Service Manual

SE-VC1180

- Notes:**
- This service manual is provided to indicate the main differences between the original model No. SE-CA1080 (E) and the subsequent model No. SE-VC1180 (E, EB, EG).
 - Refer to the Connections, Quick reference of remote control operation and Preparing of the remote control of Service manual for Model No. SL-VC1180 (E), Order No. AD9506160C2.

A OPERATION CIRCUIT

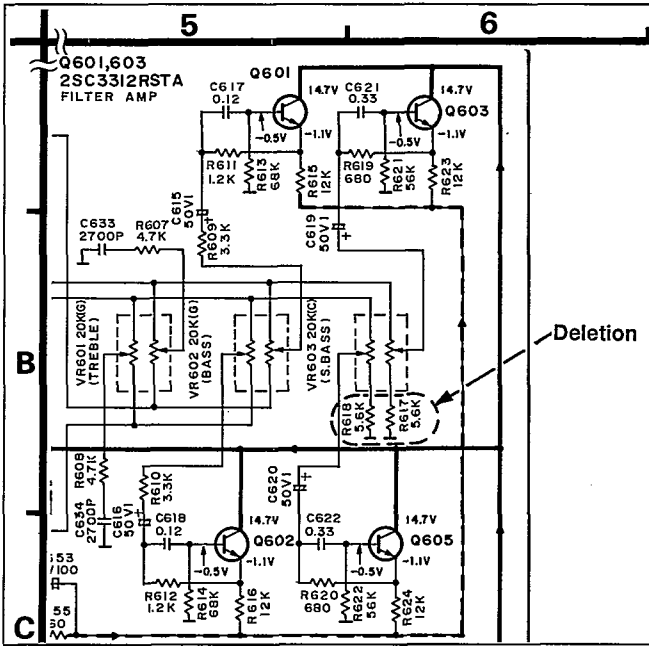
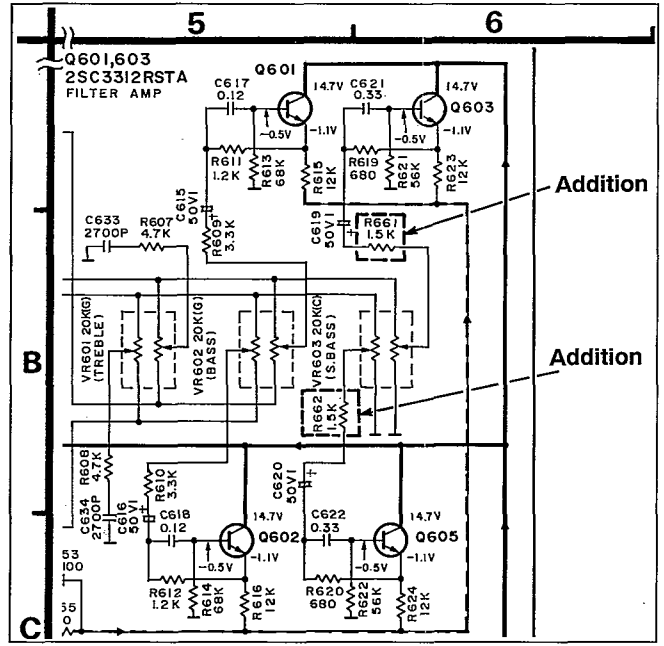
SCHEMATIC DIAGRAM (SE-CA1080 Service Manual of page 8.)

Note: Those parts have added.

A OPERATION P.C.B. (REP1924B-S)

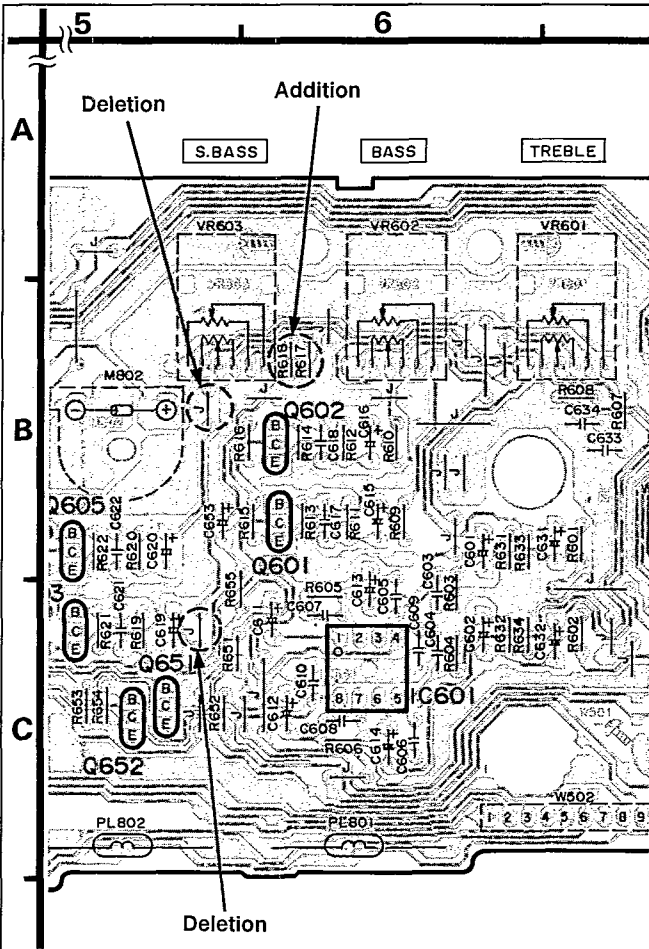
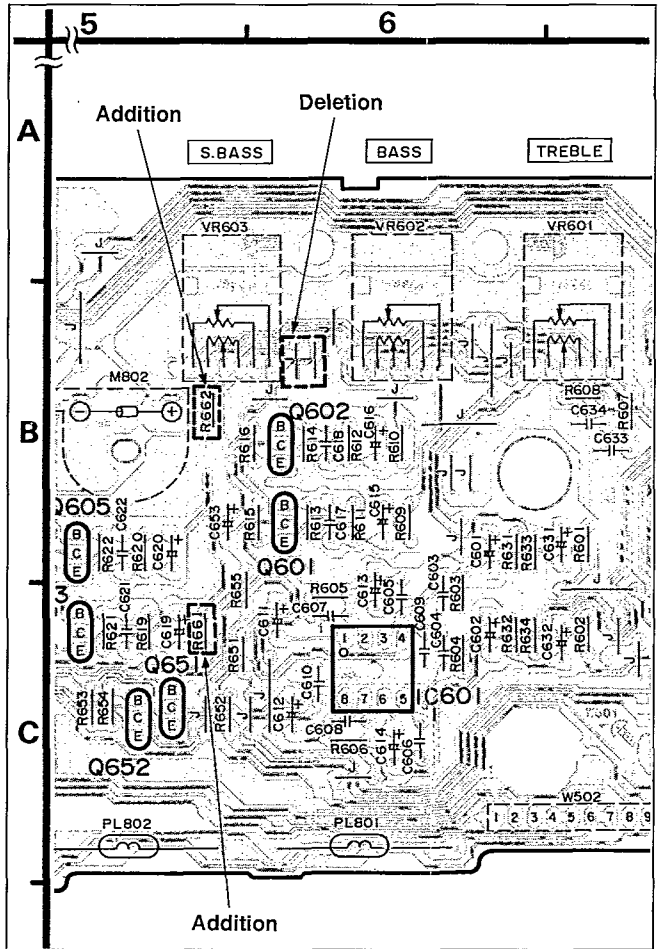
PRINTED CIRCUIT BOARDS (SE-CA1080 Service Manual of page 14.)

Note: Those parts have added.

■ CABINET PARTS LOCATION (SE-CA1080 Service Manual of page 16.)

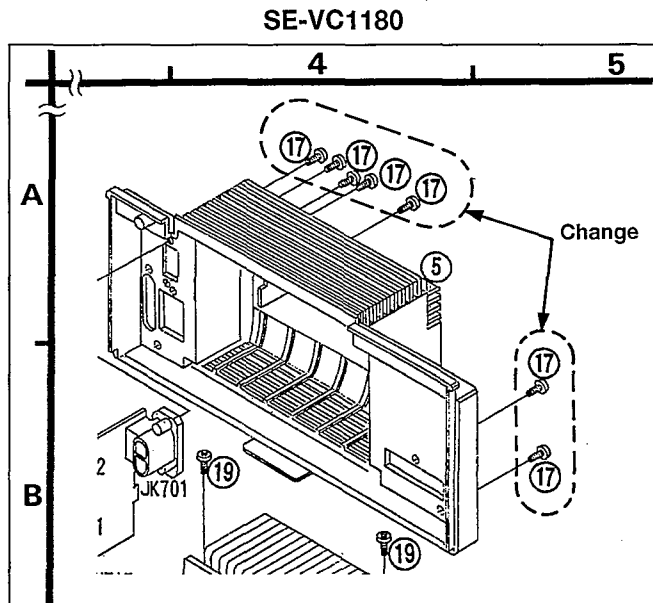
Note: Those parts have changed.
